STRUCTURAL EVALUATION OF
JOHN F. KENNEDY HIGH SCHOOL
WEST CONTRA COSTA UNIFIED SCHOOL DISTRICT
(WCCUSD)

WLC Architects
Kaiser Building
1300 Potrero Avenue
Richmond, CA 94804

DASSE Design, Inc.
33 New Montgomery Street #850
San Francisco, CA 94105
(415) 243-8400

October 17, 2002

Drawing 9: Building VIII Roof Plan

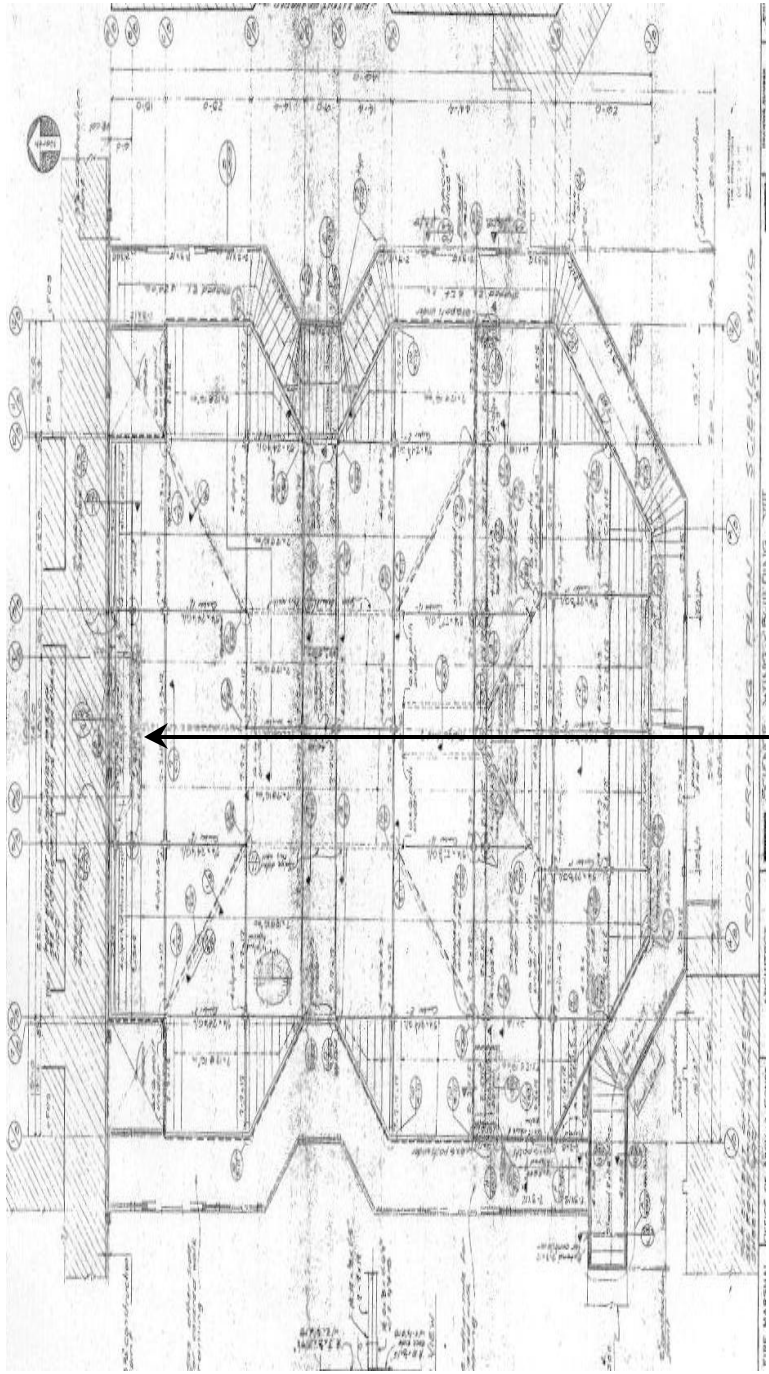
Roof framing in building VIII consists of 2x12 joists at 16" centers with 22' spans, which are supported by glu-lam beams. The glu-lam beams are supported by 6x6 wood post. The typical span of glu-lam (5-1/4"x 24-1/4") beams are 36'. The roof framing is symmetrical (with minor exceptions) about the ridgeline which is oriented in the north-south direction. The roof sheathing consists of 1/2" plywood. The roof connection (on lines B/8 and B/9) utilize 5" angle clip at 4 feet centers which do not have adequate capacity to transfer out-of-plane forces. The nails would be in withdrawal (detail 15/S12), which is not a desirable connection. The connections need to be strengthened (at all location in other buildings where this detail 15/S12 has been used).

24.	Building VII – Connection between roof and plywood shear wall is inadequate to resist seismic force.
25.	Building IX – Diaphragm is overstressed between grids 1 to 10 for seismic loads in north-south direction.

Strengthen roof to shear wall connection on this line
